**AUTHORIZATION TO DISCHARGE UNDER THE  
NATIONAL POLLUTANT DISCHARGE ELIMINATION SYSTEM**

**Holtec Decommissioning International, LLC**

**Pilgrim Nuclear Power Station  
600 Rocky Hill Road  
Plymouth, MA 02360**

Figure 1. Schematic of a Beaudrey WIP Screen. (Source: Beaudrey).

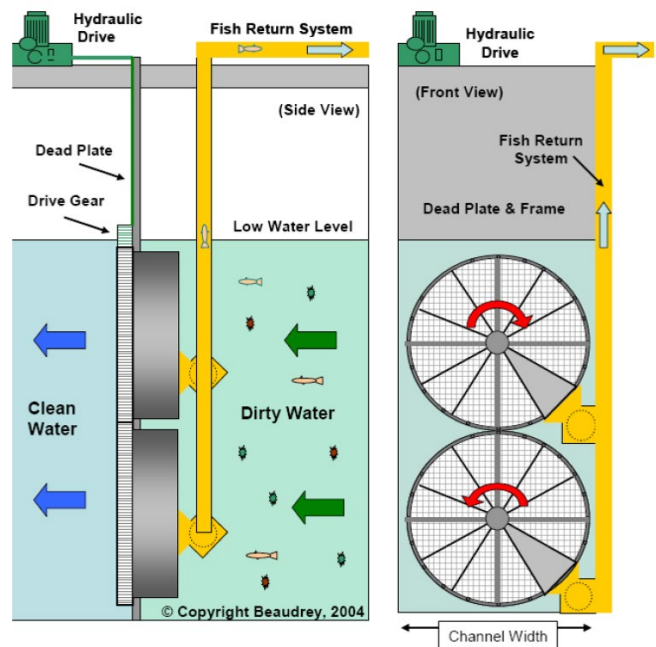
Finally, the commenter asserts that other available technologies to reduce impingement and entrainment at PNPS, such as the Beaudrey Water Intake Protection (WIP) screen or modified traveling screens, were not fully considered. WIP screens are designed with large disks divided into pie-shaped wedges that rotate around a center axle perpendicular to the intake flow (Figure 1). A stationary suction scoop mounted over one section of the disk vacuums debris and organisms as each wedge rotates under the scoop. A fish-friendly pump transports the organisms and debris to a return trough. *See* AR-717 at 2-7. This design eliminates "carryover" because the screen face, vacuum, and pump are all located on the same side of the screen. The screen material is designed to minimize impacts and organisms remain submerged for the duration of impingement and transport to the source water body. The commenter supports this technology, noting that the WIP screen "appears to achieve improved results to reduce mortality from impingement and entrainment and is capable of handling velocities of 0.5 fps." The comment states that the WIP screen's fish return system is gentler than the traveling screen and backwash system and that studies have observed benefits to species found at PNPS.<sup>26</sup>

In the Draft Permit, EPA did not consider traveling screens, including the WIP screen, as an available technology for entrainment, because this technology is not considered effective for reducing entrainment.<sup>27</sup> Screens must consist of fine mesh to prevent entrainment of eggs and larvae, and fine mesh screens may lead to increased mortality of impinged eggs and larvae that would have otherwise been entrained. *See Technical Development Document for the § 316(b) Existing Facilities Rule (TDD)* at 6-23 and 6-45 to 48. WIP screens have been shown to be as effective or even more effective than modified traveling screens for reducing impingement mortality for many species. *See Id.* at 6-40 to 41. However, WIP screens to reduce entrainment at PNPS would likely have to be fitted with mesh sizes in the range of 0.5 to 1.0 mm. In addition, there are technical challenges to the installation of WIP screens that must be considered in an evaluation of this technology for PNPS.

design, the WIP screen has a smaller dimension than the conventional traveling screen (see Figure 1). If the same number of screen bays are replaced with the WIP screens, the through-screen velocity will increase because the flow rate will be withdrawn through a smaller screen area. If PNPS were to install WIP screens without increasing the existing through-screen velocity (or to achieve, as the comment suggests, through screen velocities of no greater than 0.5 fps), the existing intake structure would have to be expanded to accommodate additional screens. Similarly, because the screen mesh affects the velocity, decreasing the mesh size of WIP screens to exclude early life stages of marine fish (*e.g.*, less than 1 mm) would also necessitate additional screens to accommodate the required cooling water volume, which would require expansion of the existing intake structure. Expanding the intake structure would be more costly and would likely add a significant amount of time to the project as compared to simply installing new WIP screens in the existing bay. From a technical standpoint, while a WIP screen may be feasible for PNPS, it is not likely that it would meet the BTA requirements indicated in the comment without significant expansion of the CWIS. Moreover, the technology is not as effective as reducing impingement mortality and entrainment as the flow and intake velocity BTA requirements that can be achieved with the flow reductions associated with the shutdown.
